FOR PERCOLATION TESTING AND SITE EVALUATION

PROPERTY LOCATION
SUBDIVISION/PROPERTY NAME GREENBRIDGE RD - BISHOP ESTATE LOT NO. 2

PROPERTY ADDRESS 3911 GREENBRIDGE RD, DAYTON, MD
STREET TOWN/POST OFFICE

RE: PERCOLATION TEST RESULTS – A522951
Tax Map 28, Parcel 97
Green Bridge Road

perc application, test plan,
Aug. 2, 2005

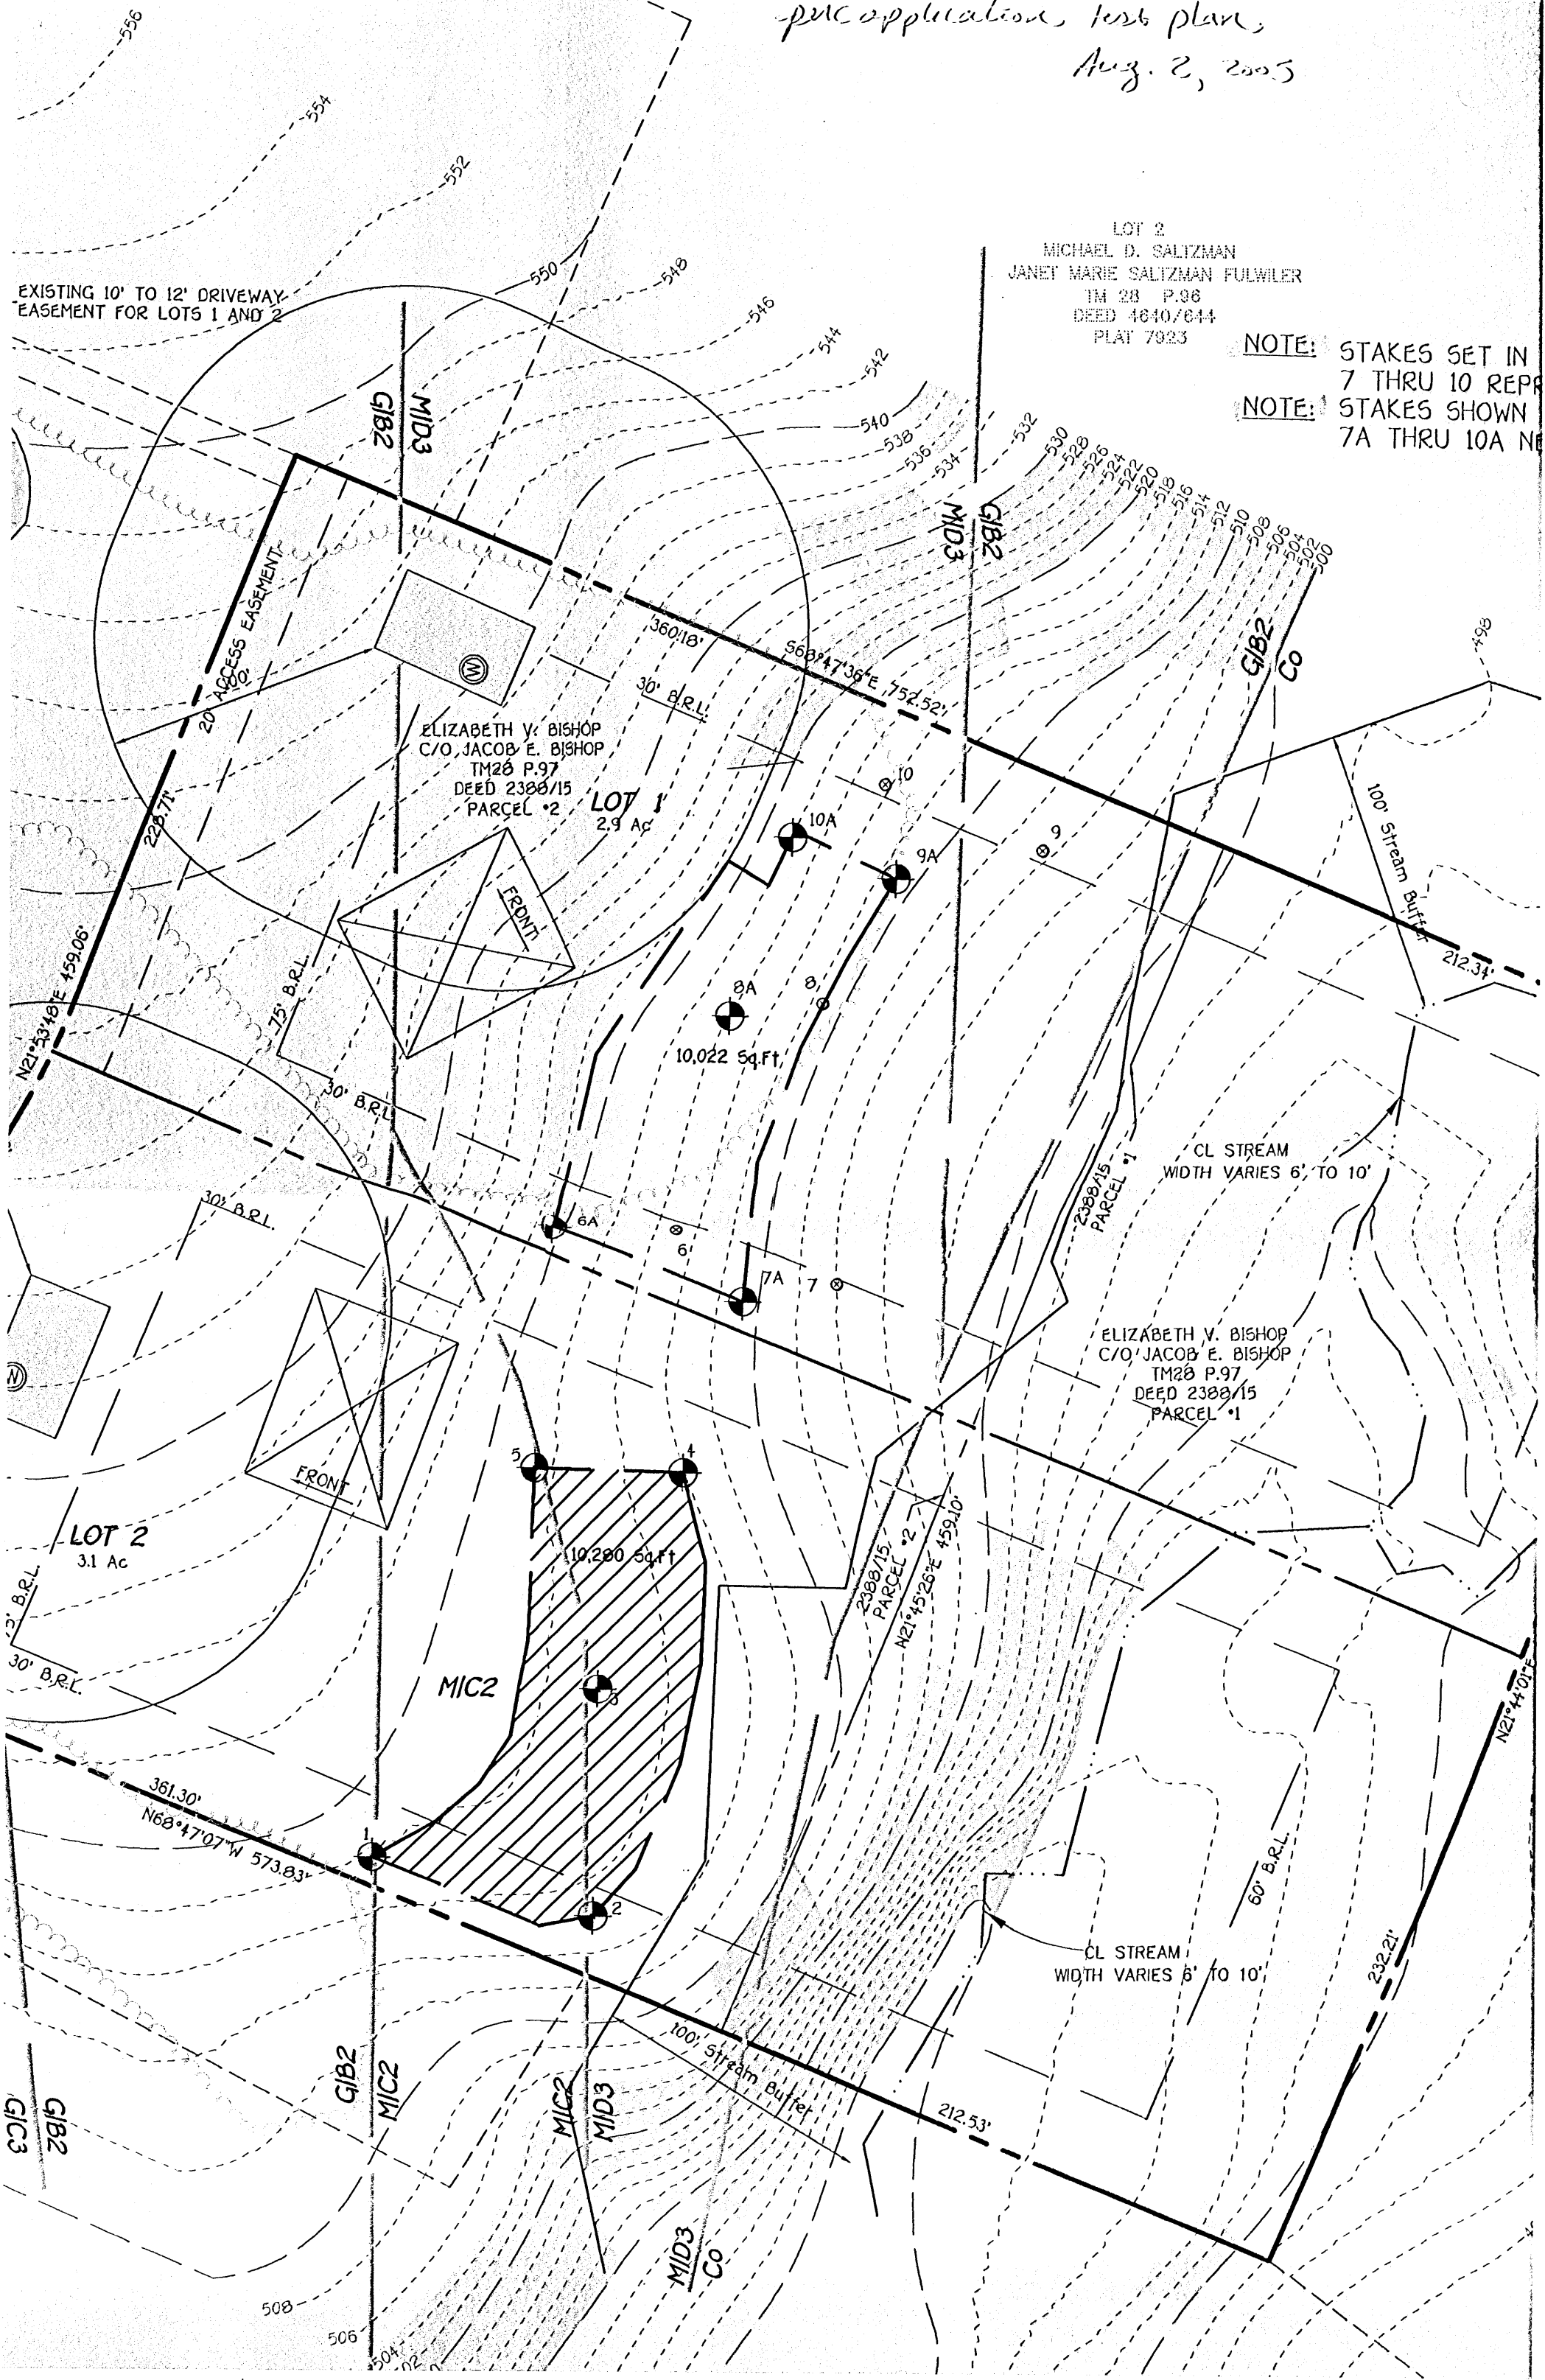
Percolation testing conducted August 17, 2005 on the referenced property indicated satisfactory soil conditions. Copies of the test results are enclosed.

Further review is contingent upon submission by a registered engineer/surveyor of a percolation certification plan showing the following:

- 1) Actual locations and elevations of all excavated test holes
- 2) Proposed house, well and septic system
- 3) Locations of any other relevant features such as streams, swales, or existing structures
- 4) A note must be included certifying that all existing wells within 100 feet and septic systems within 200 feet of property boundaries have been shown
- 5) A note indicating that depicted topography reflects field-matched information
- 6) A health officer signature block stating “approved for private water and private sewer systems”
- 7) A MDE sewage disposal area statement is required
- 8) MDE minimum lot width statement

The percolation certification plat should be submitted within 60 days to allow field verification if necessary. If you have any questions regarding this matter, please contact me at the above address or by calling (410) 313-1771.
